IREDELL COUNTY HEALTH DEPARTMENT

(SEPTIC TANK) IMPROVEMENTS PERMIT AND CERTIFICATE OF COMPLETION
(Ground Absorption Sewage Disposal System – G. S. Chapter 130-Article 13C)

SUBDIVISION NAME CELESTE ESTATES LOT NO. 5 + 6 SECTION OR BLOCK NO.

Plot of System

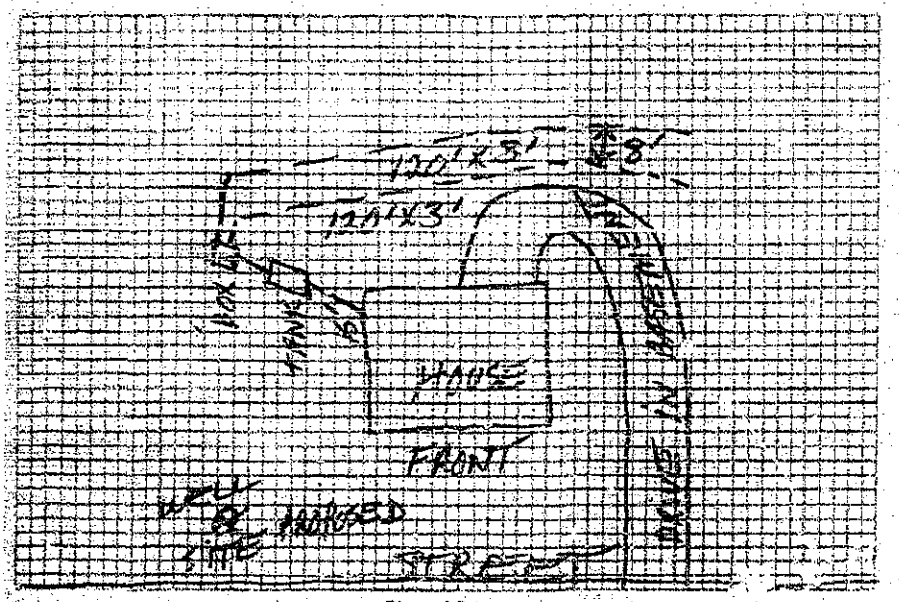
COMMENTS: Stay out of hill with drainlines. The hill ahead behind the house should be pushed on down. Fill transmitted out to appear there won't be over 6"-12" of fill near drainfield. Keep well at least 50' from S.T. system

The proposed Garage addition does not appear to impact the existing septic system.
**NOTE:
